## PS-0381 GEN3 DataVault LCD Display Modification

PROCESS  
SPEC

DOC #:		PS-0381		REV	
MODEL:		5025-0149		A	
SERIAL:		All		DATE:	08/21/2020
BY:	RMR	CK'D:	-	REV:	08/21/2020

**Date: October 21, 2020  
Person Contacted: Robert Hust (witness)  
NTSB Accident Number: WPR20LA315**

Figure 3 - Keypad and Fan Cables

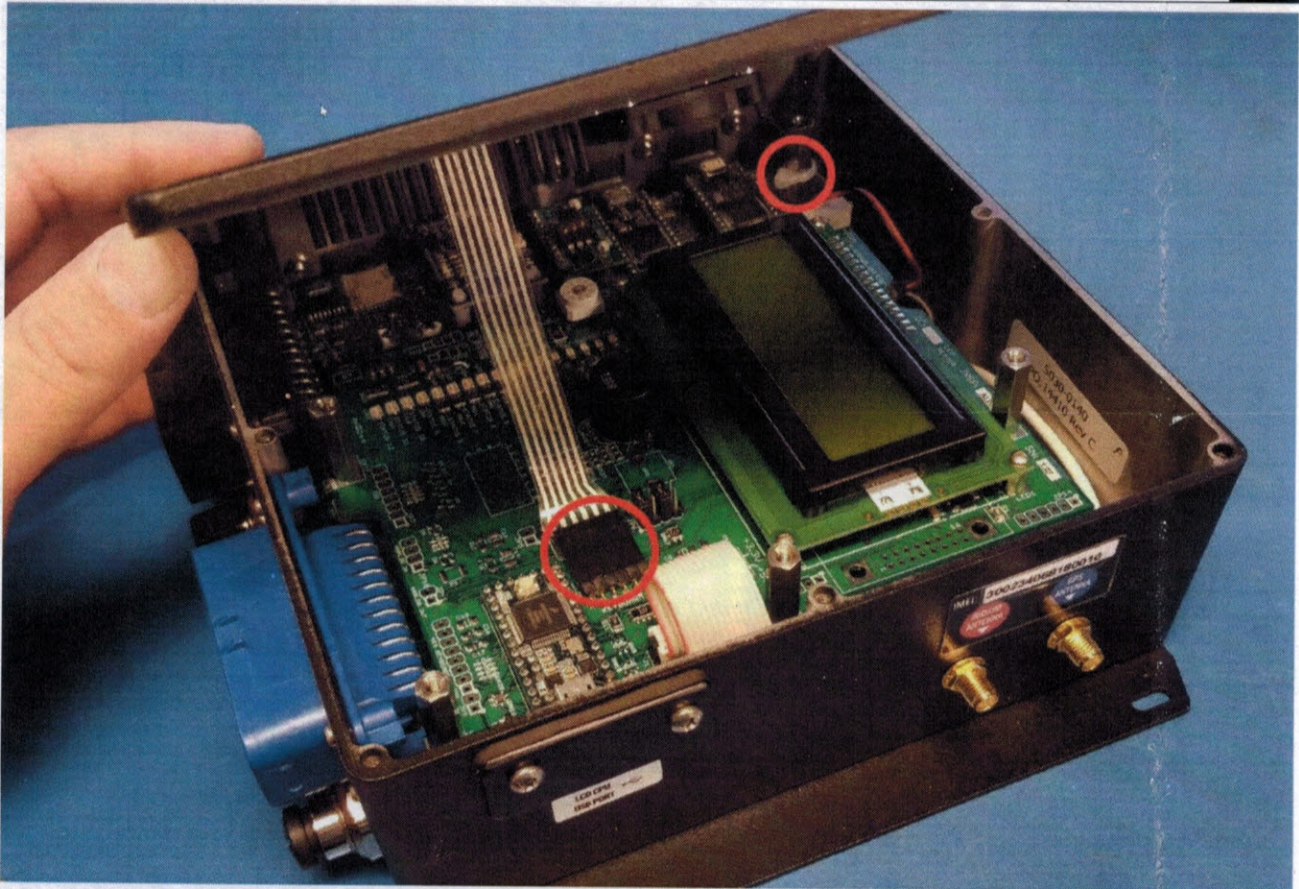
- The lid is attached to the PCB inside by a keypad ribbon cable, as well as a fan power cable, which should be zip-tied to a standoff on the PCB (see Figure 3). Gently remove the keypad ribbon cable, and set the lid carefully aside, making sure not to strain the fan cable. It may be necessary to remove the zip-tie to have enough wire length to work with.

**Figure 4 - LCD Ribbon Cable Location**

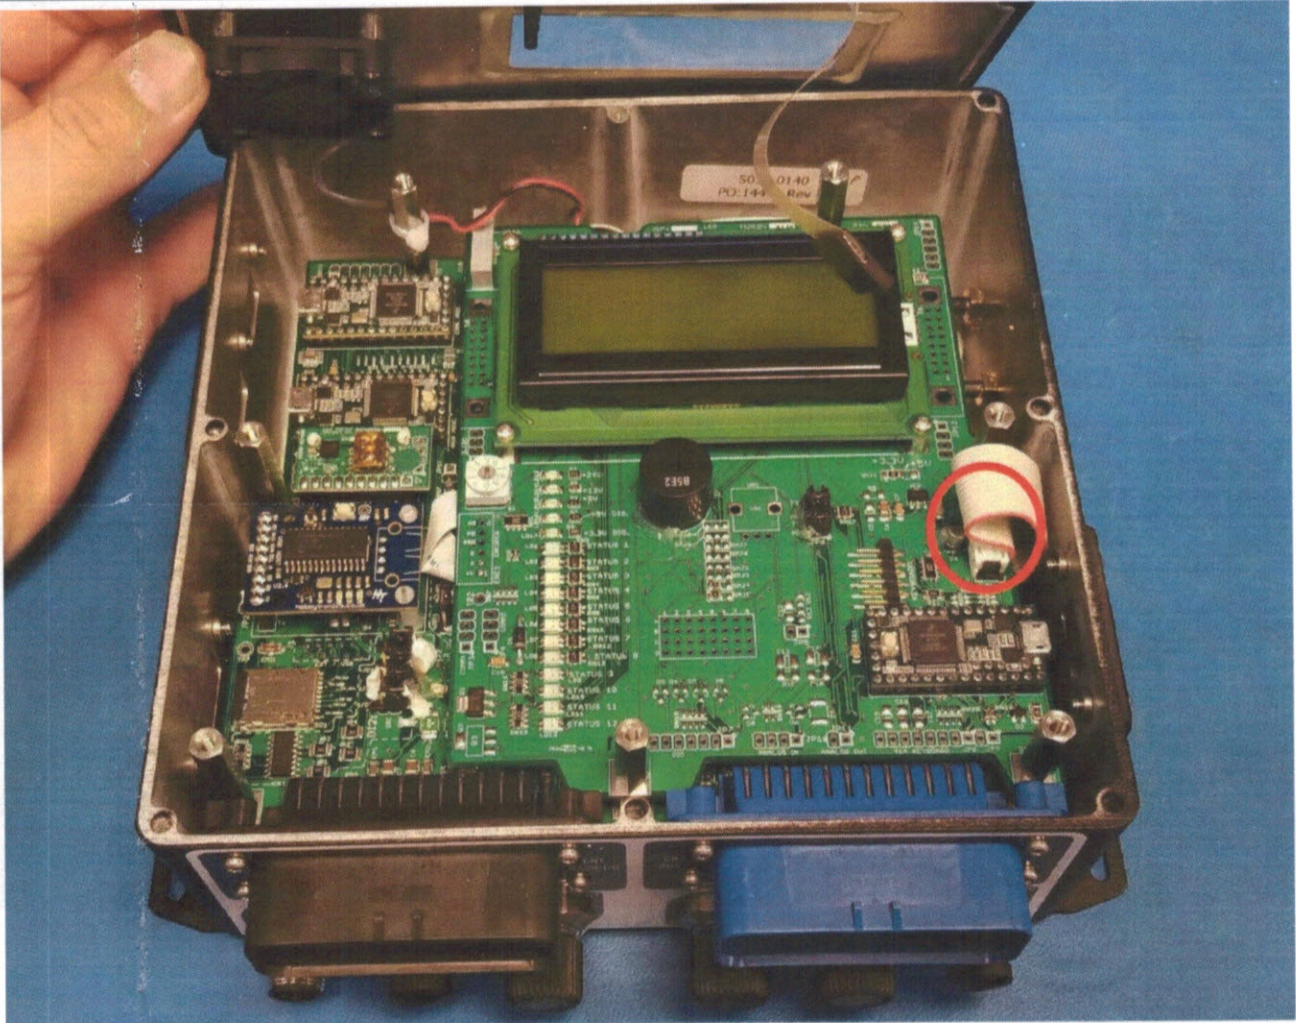
- Locate the ribbon cable on the same side of the enclosure as the "LCD CPU" access plate (see Figure 4). Carefully lift straight up on the ribbon cable connector to remove it.

**Figure 5 - LCD Ribbon Cable Connector**

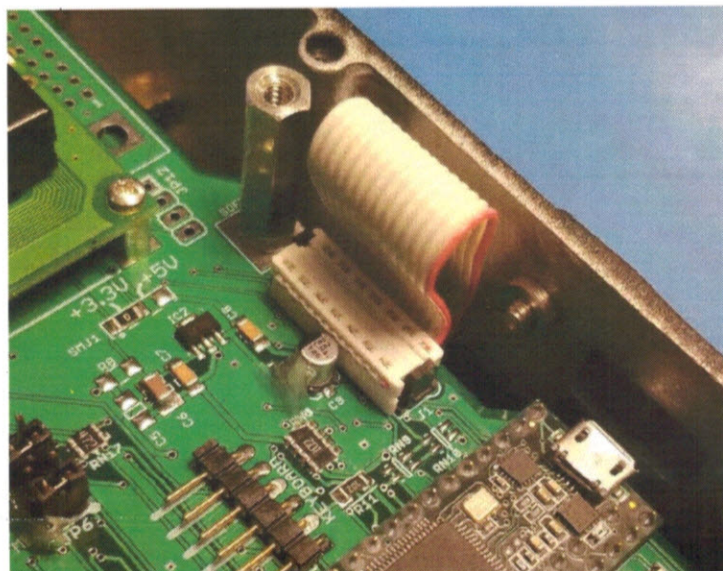
- Take care not to break the keying tabs on the connector.

Figure 6 - Securing LCD Ribbon Cable

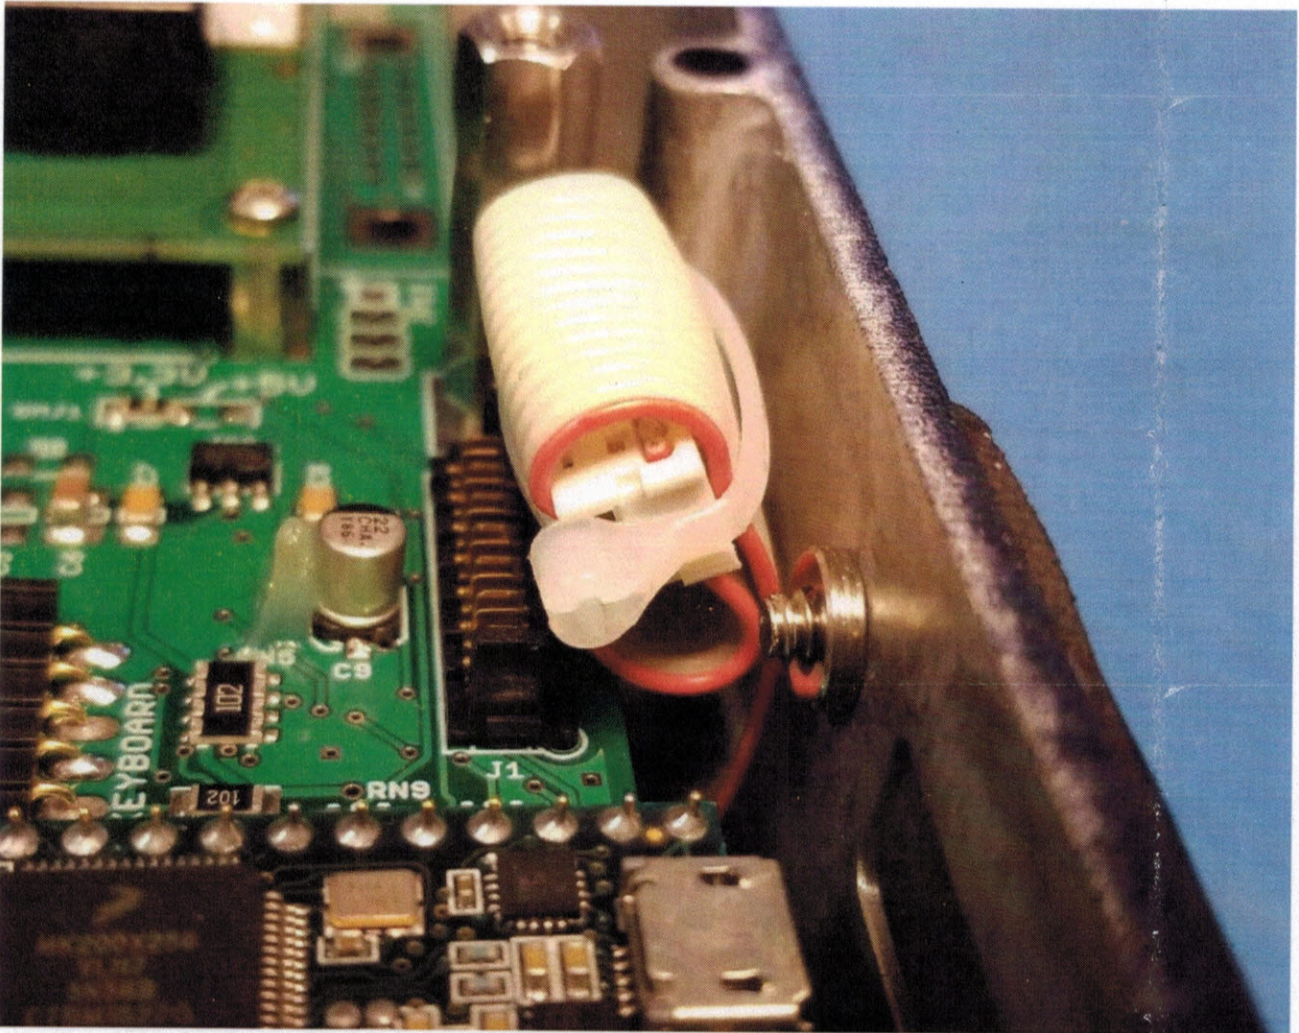
- Roll the ribbon cable connector inside the cable to protect the contacts from shorting anywhere, and secure with a small zip-tie as shown (see Figure 6).
